Date : Le 23 février 2021	Addenda/Addendum : A-M-01
À/To : Agence spatiale canadienne Centre spatial John H. Chapman 6767, route de l'Aéroport St-Hubert (Québec) J3Y 8Y9	Projet/Project : Agence spatiale canadienne Réaménagement vestiaire des femmes
	N° de projet : 27200022
Att. : Mme Josée Brassard	Propriétaire : Agence spatiale canadienne
Distribution : Par ASC/By CSA

FIN DE L'ADDENDA A-M-01

projet:
PAVILLON 4
RÉFECTION DOUCHES
VESTIAIRES DES FEMMES
 6767 route de l'aéroport, Saint-Hubert, Qc

CE PLAN NE PEUT ÊTRE UTILISÉ POUR SOUMISSION QUE S'IL EST SCÉLÉ, SIGNÉ ET ÉMIS POUR SOUMISSION.
 CE PLAN NE PEUT ÊTRE UTILISÉ POUR CONSTRUCTION QUE S'IL EST SCÉLÉ, SIGNÉ ET ÉMIS POUR CONSTRUCTION.

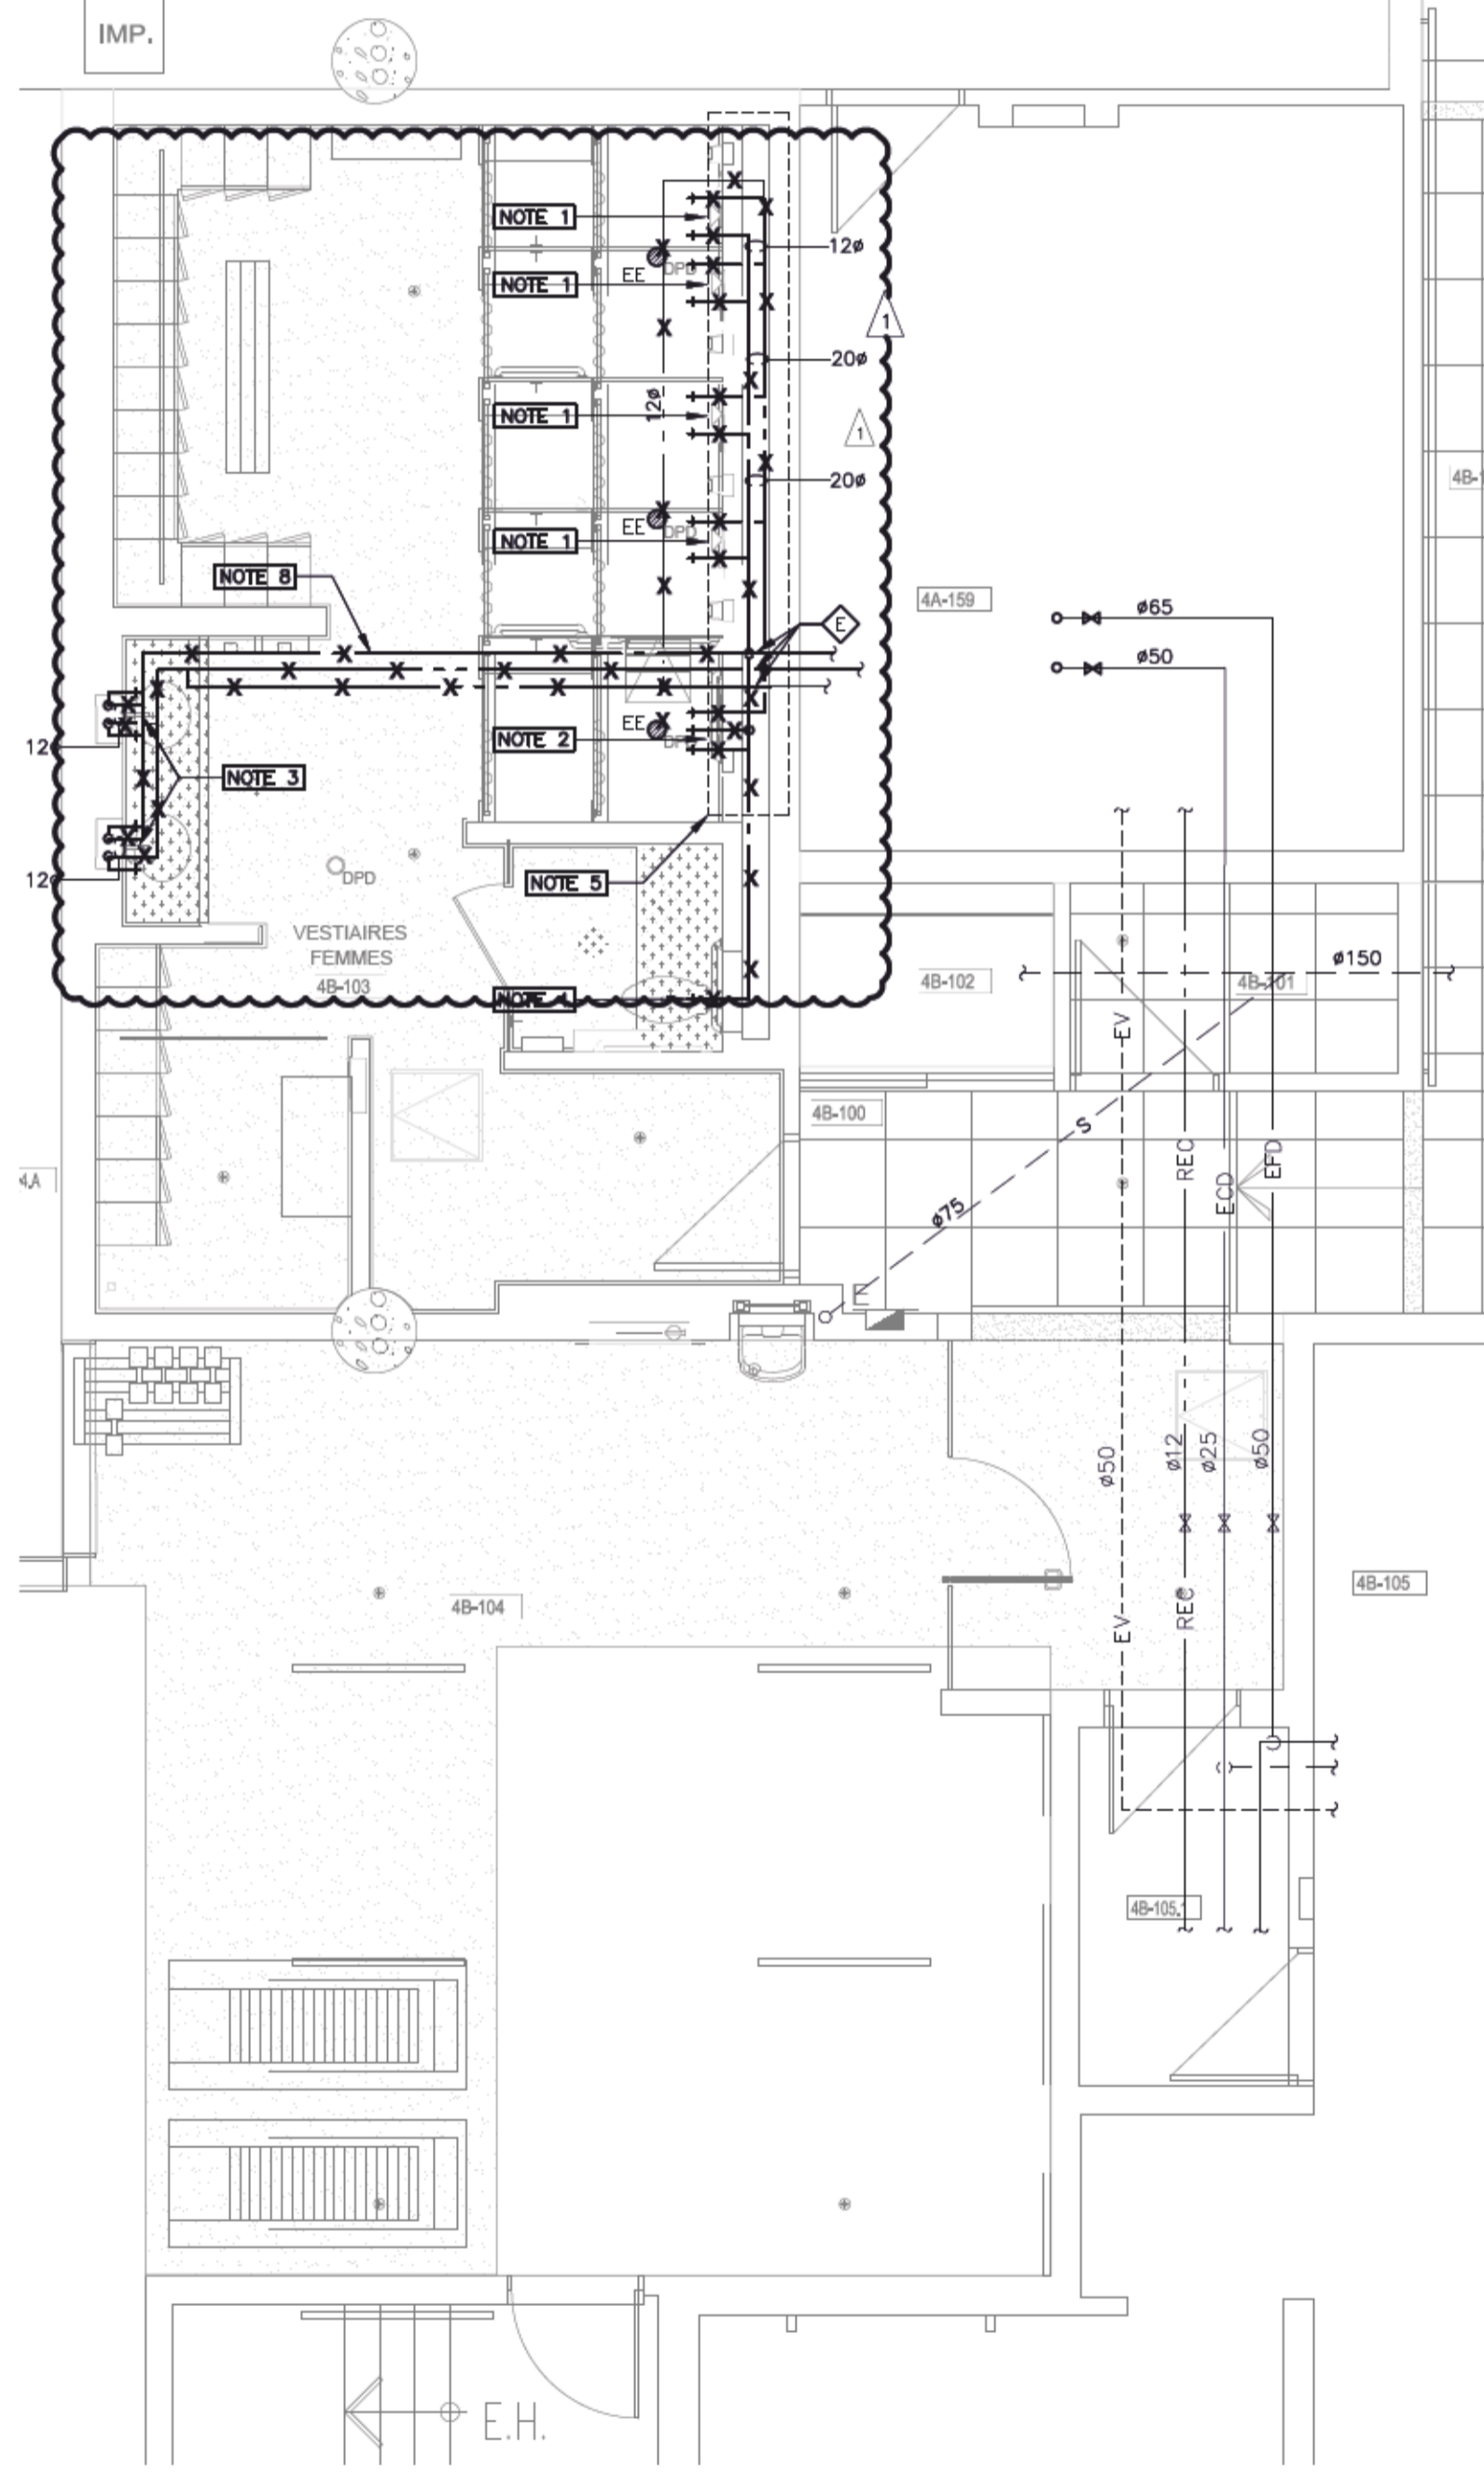
<u>Lexique pour motifs</u>	Motifs
Demande du client : DC Coordination de chantier : CC Coordination des professionnels : CP Conséquence des travaux de base : CB	
<p><i>Le présent addenda fait partie intégrante des plans et devis de mécanique émis pour soumission en date du 19 novembre 2020.</i> <i>This addendum is an integral part of the drawings and specifications issued for tender november 19th, 2020.</i></p> <p>1. <u>MÉCANIQUE/MECHANICAL</u></p> <p>1.1. Plan M211 - Plomberie / Plumbing</p> <p>a) Modification de la portée des travaux de remplacement de la tuyauterie d'alimentation en eau domestique. / Modification of the scope of work for the replacement of domestic water supply piping.</p> <p>1.2. Plan M511 - Ventilation / Ventilation</p> <p>a) Correction du plan concernant le déplacement du conduit de 175mm de diamètre. / Correction of the plan regarding the relocation of the 175mm diameter duct.</p>	<p>DC</p> <p>CP</p>
